TOWNSHIP OF LOWER MERION

BUILDING AND PLANNING COMMITTEE

AGENDA

ITEM: TENTATIVE SKETCH PLAN - 21 Bala Avenue, Bala Cynwyd, Ward 9, LD# 3923TS

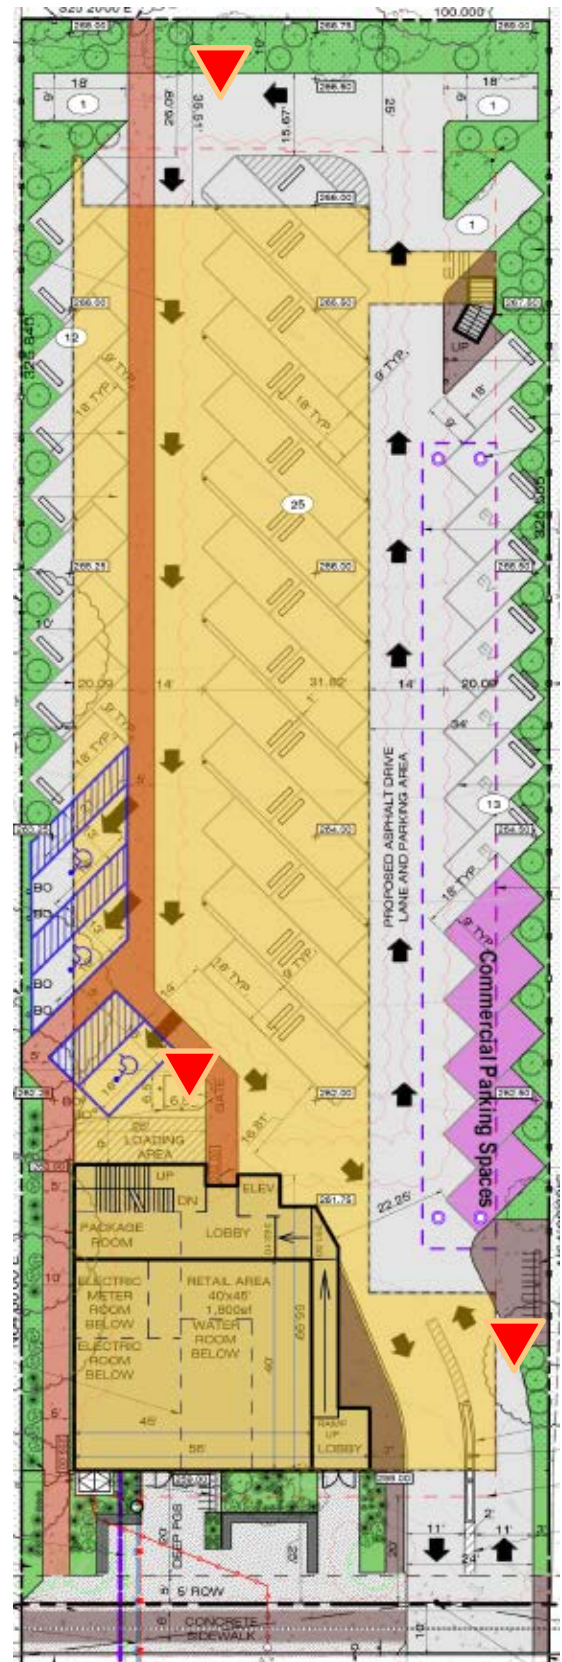
The Applicant proposes to provide the required pedestrian pathway within the drive aisle. As required, the pathway will be delineated by a change of material. Plans show the pathway material will be concrete. Additionally, plans show several pedestrian yield signs and bollards.

While a material change serves to delineate a pathway, it will not clearly separate pedestrians from vehicles as required by Code §135-4.9(Q)(7) which states that the pathway “be physically delineated and provided through the installation of sidewalks and defined crosswalks.”

RCA #3: The pedestrian pathway in the vehicle use area shall be an impression-style stamped asphalt if the requested waiver is approved. The applicant shall provide additional delineation that may include a painted ceiling where the pathway is covered by the proposed structure and additional signs and bollards as determined to be necessary upon preliminary plan review.

Location & Existing Conditions

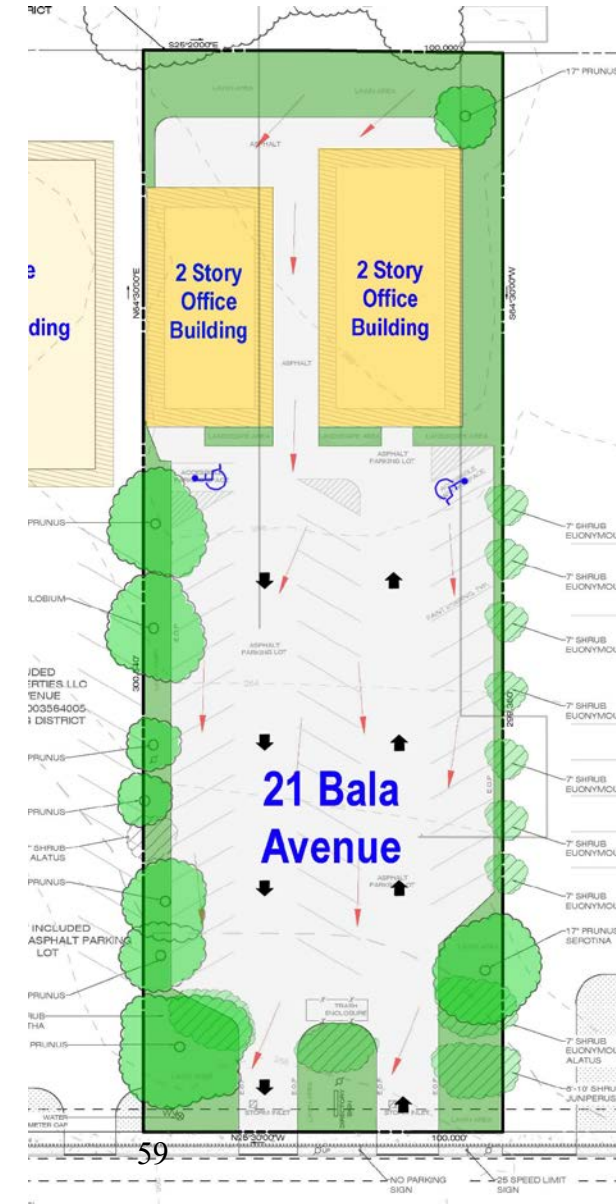
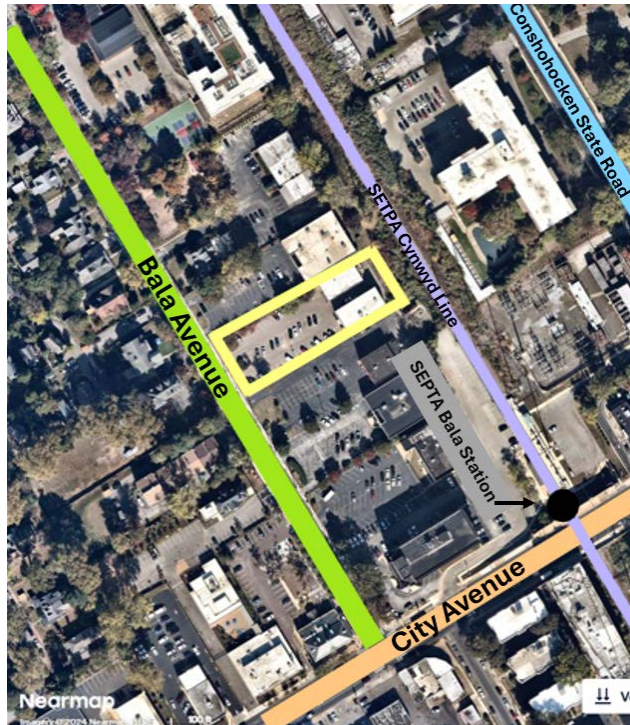
Consideration 1

Connect the pedestrian pathway to the commercial parking spaces.
